Application Serial No. 10/736,348
Amendment dated March 9, 2007
Reply to Office Action dated December 19, 2006

Amendments to the Drawings

REMARKS/ARGUMENTS

Fig. 8

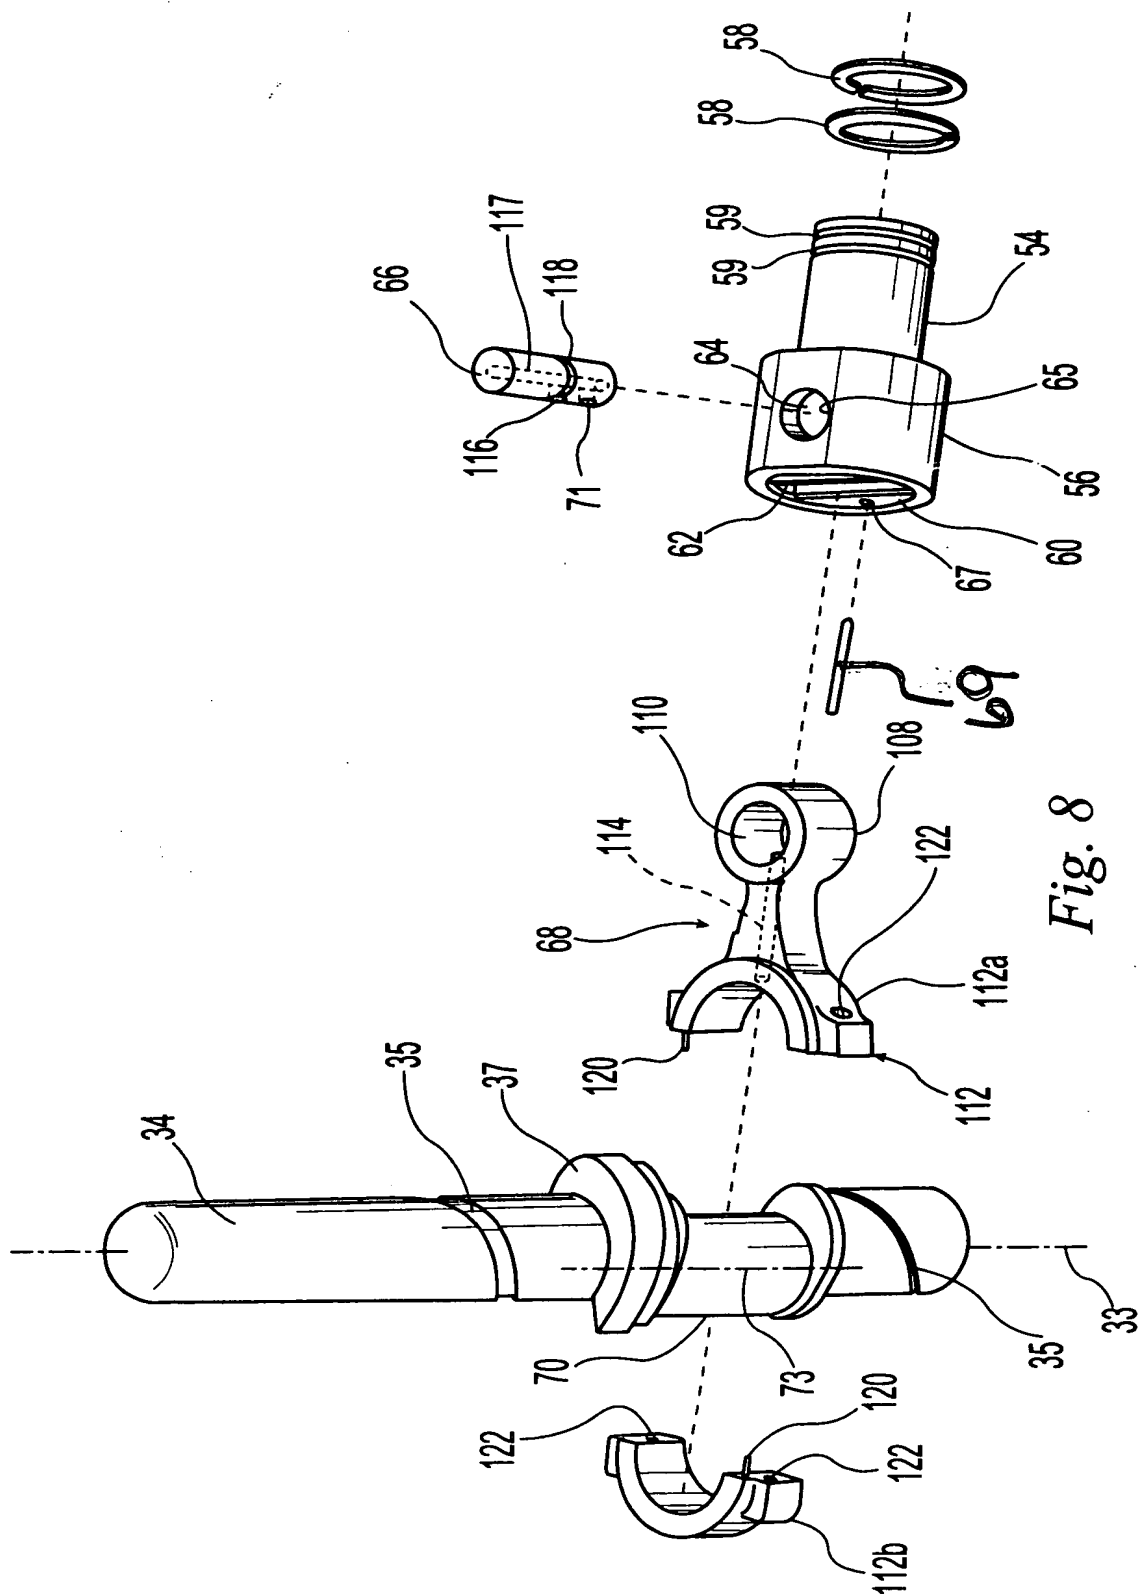
In response to the Examiner's objection to the specification regarding the failure to depict locking pin 69 in the drawings, locking pin 69 has been properly labeled in Fig. 8. Applicant has also submitted herewith a Replacement Sheet of formal drawings and an Annotated Sheet showing the foregoing changes.

The attached sheet of drawings includes a change to Fig. 8. This sheet, which includes Fig. 8, replaces the original sheet including Fig. 8. In Fig. 8, a previously omitted reference to locking pin 69 has been added.
